PRATT & WHITNEY CANADA
SERVICE BULLETIN

P&WC S.B. No. 41120R2

PT6C-67C BS963 AND BS1019 TO PT6C-67C1 BS1447 AND BS1448 - CONVERSION OF

Jun 23/2021
Revision No. 2: Jul 25/2022

EEC Reprogramming kit PWC 77701 Rev.A
Figure 1 (Sheet 1 of 2)

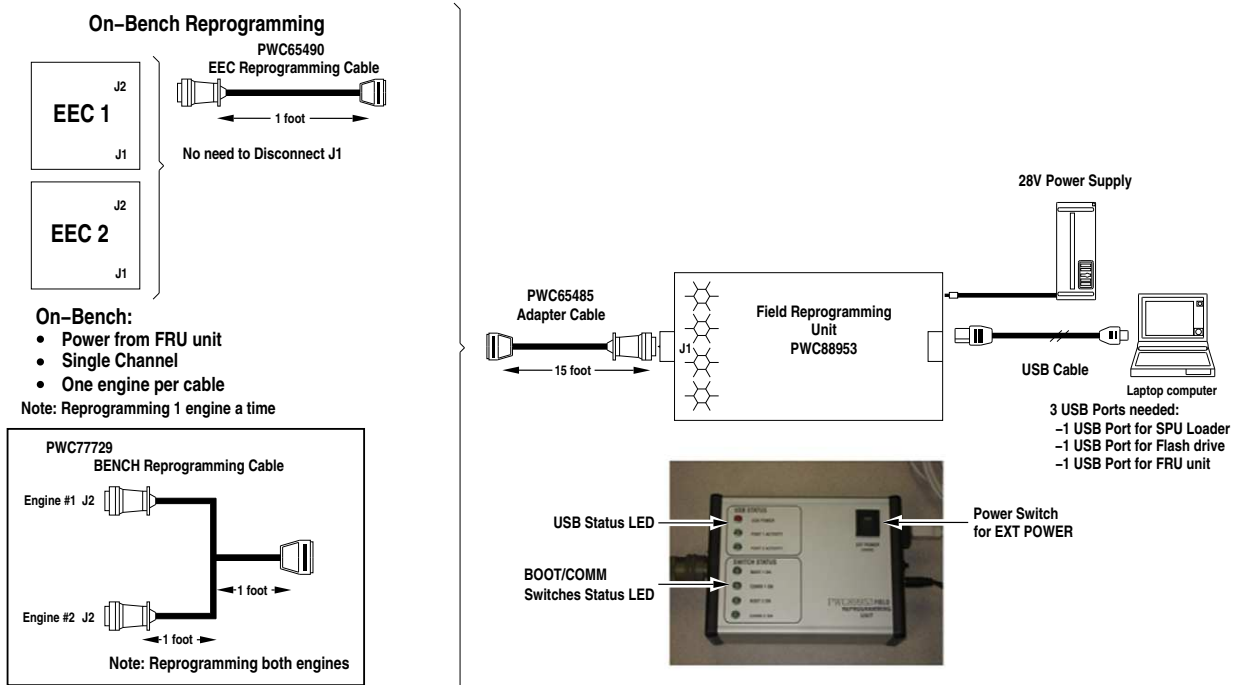
A. You can reprogram the EEC with the tools described in Section 2.E as follows:

Location of identification and software identification plates on EEC
Figure 2

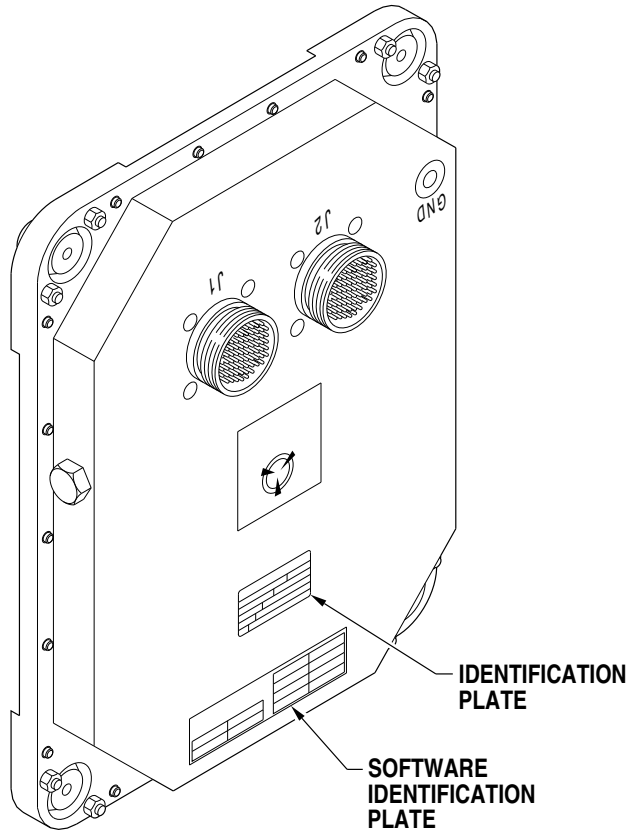
- (c) Carefully remove the old EEC identification plate.
- (d) Clean the area where the new plate will be attached (Ref. Fig. 2) with isopropyl alcohol and wipe dry with a clean, lint-free cloth. Make sure to fully remove the old adhesive.
- (e) Let the area dry thoroughly.
- (f) Remove the paper from the back of the new EEC identification plate.
- (g) Put the new plate in position on the EEC.
- (h) Use a soft rubber roller or equivalent soft tool and apply pressure to the plate to have firm contact with the EEC housing. Make sure there are no air bubbles caught between the identification plate and EEC housing.

- (2) If the EEC was reprogrammed in the field proceed as follows (Ref. Fig. 3):
